**TOWN OF BAY HARBOR ISLANDS
MORRIS N. BROAD COMMUNITY CENTER
1175 95TH STREET
BAY HARBOR ISLANDS, FL 33154**

DEVELOPMENT & REVIEW COMMITTEE MEETING

Subject: Site Development Plan Application (2nd DRC Review)
1085 Townhouses – 6 DU Townhouse Complex
1085 94th Street
Bay Harbor Islands Acct. No. SPR24-000025
MMPA Account No. 01-0702-1197

MMPA recommends the Development Review Committee (DRC) **DEFER** action on the proposed Site Development Plan application at this time to allow the applicant's design team to address the listed comments. The submittal package has several design / Code violation issues, some of the plans are inadequate or missing and a few other items need to be corrected.

A BUILDING SECTION

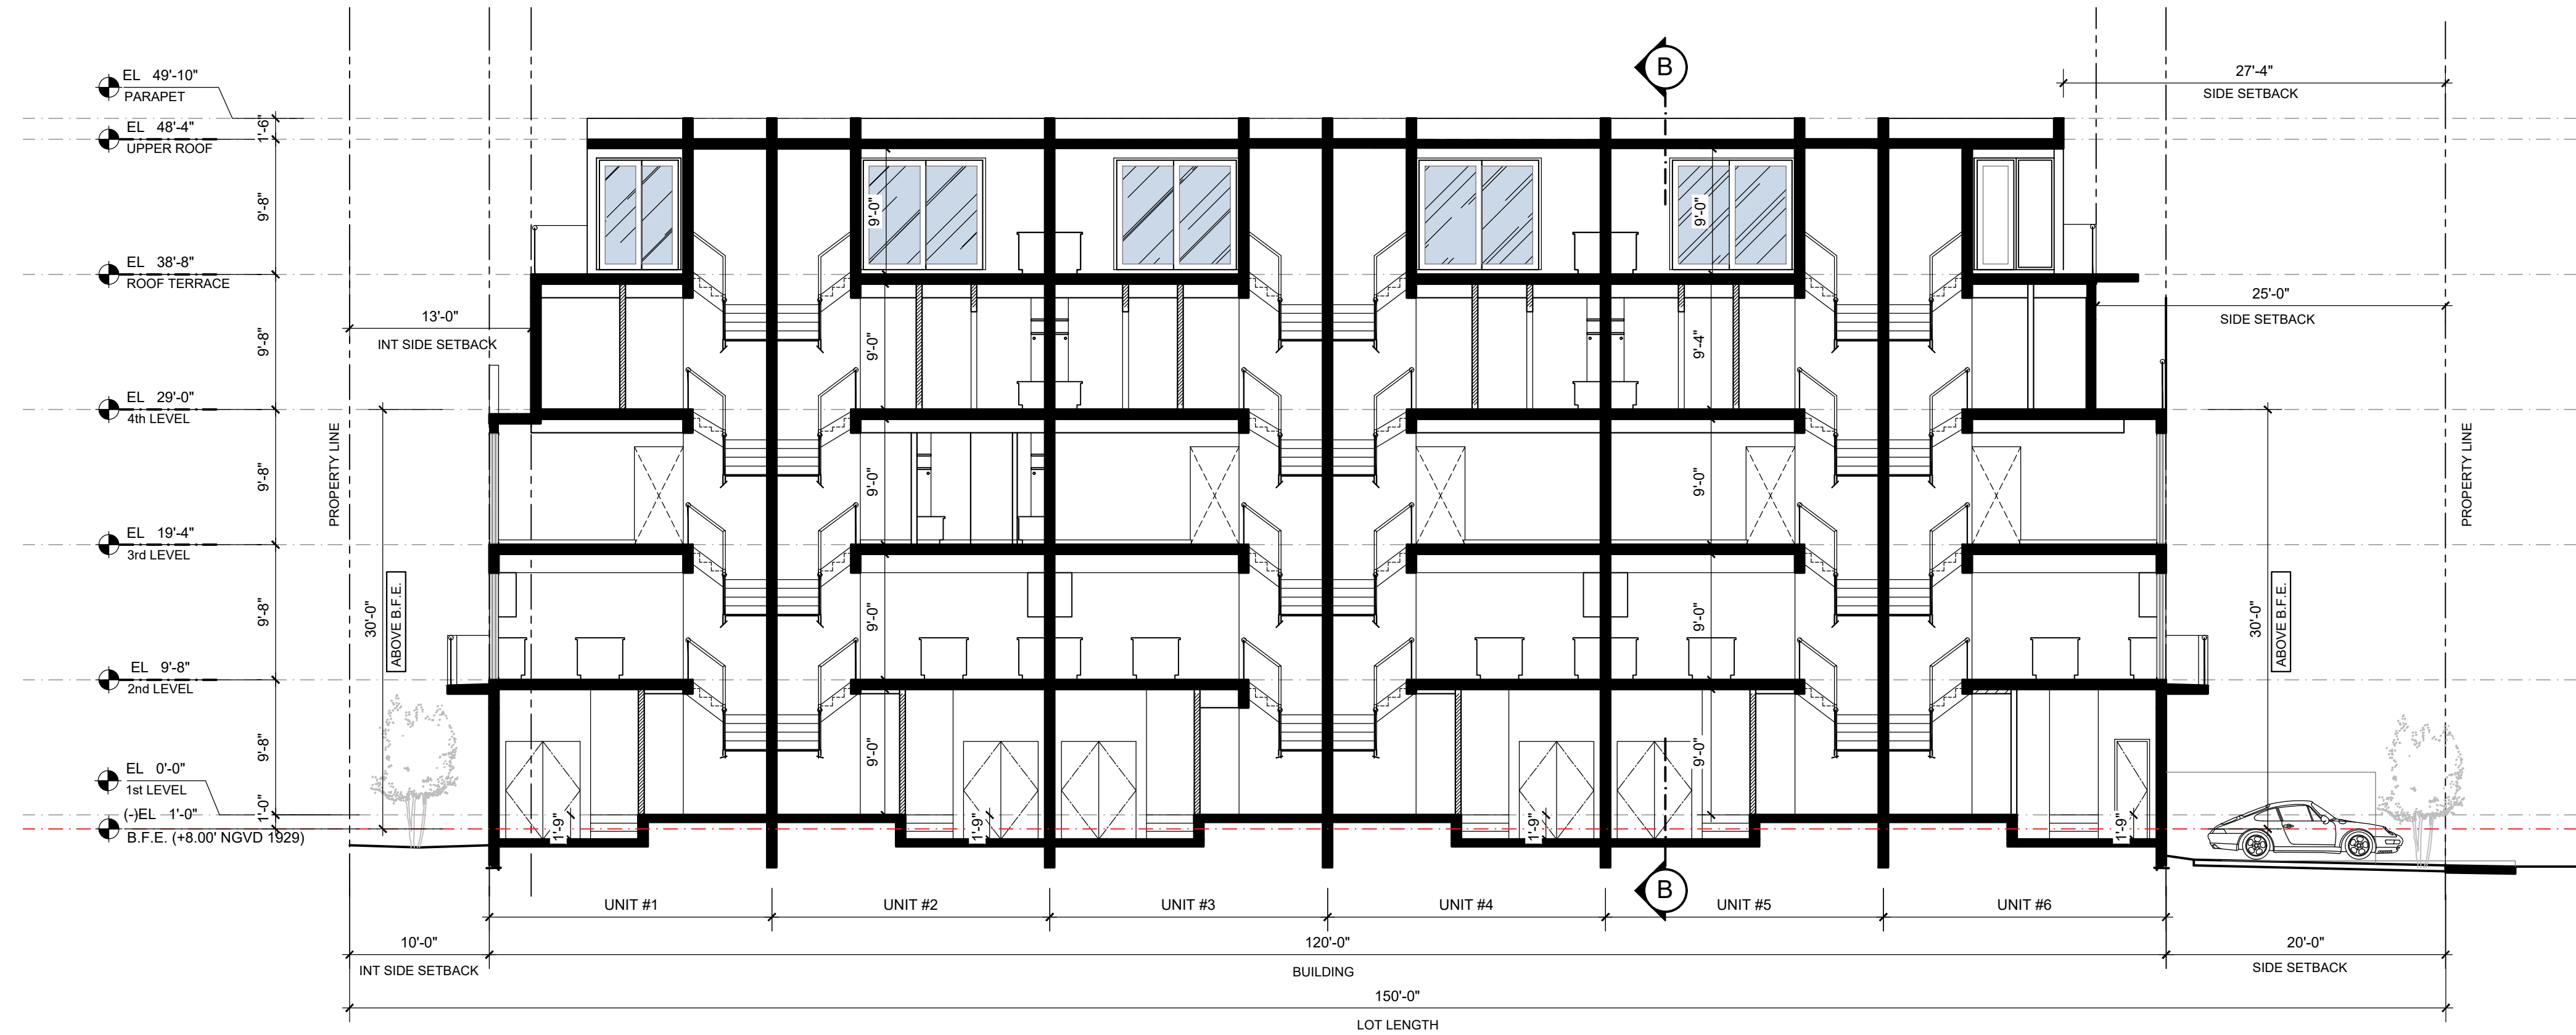
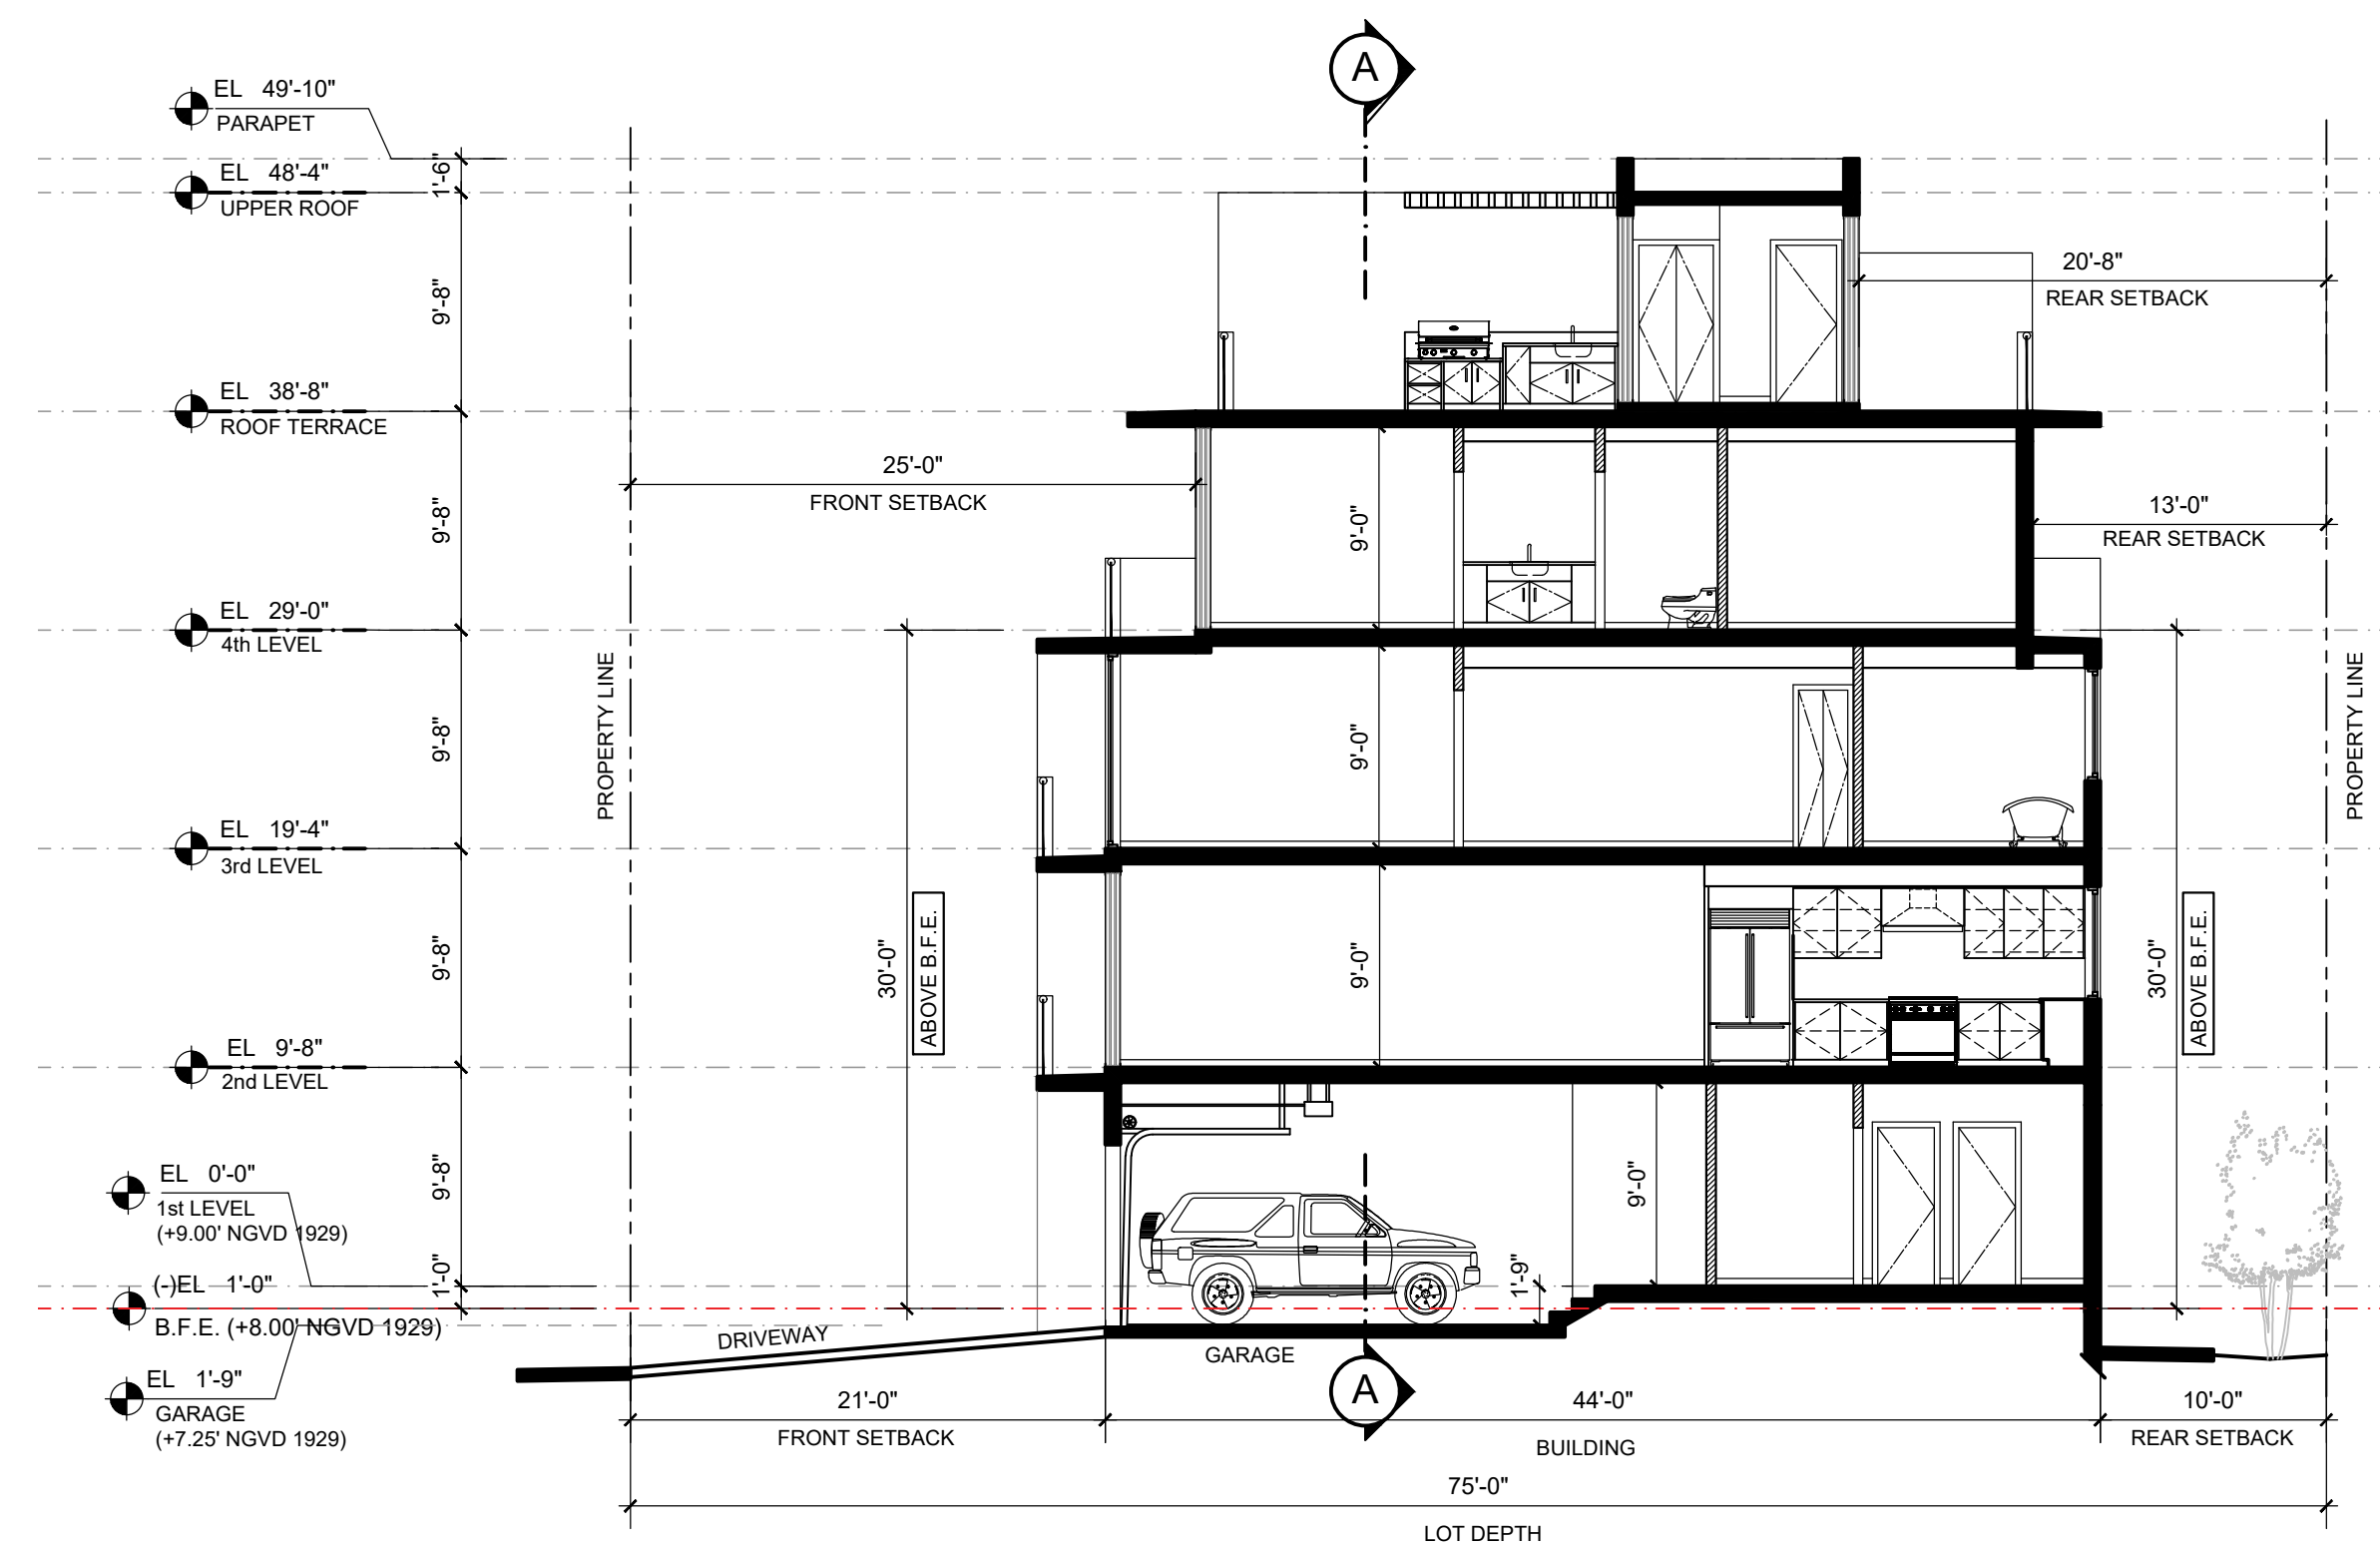
- Sheet A-4 Building Section shows a floor to ceiling height of 8'. The Code minimum is 9' from the top of one floor slab to the bottom of the floor slab above it. Please revise.

New clear height provided. No height is less than 9ft from top of slab under side of slab above. Refer to sheet A-4 (sections)
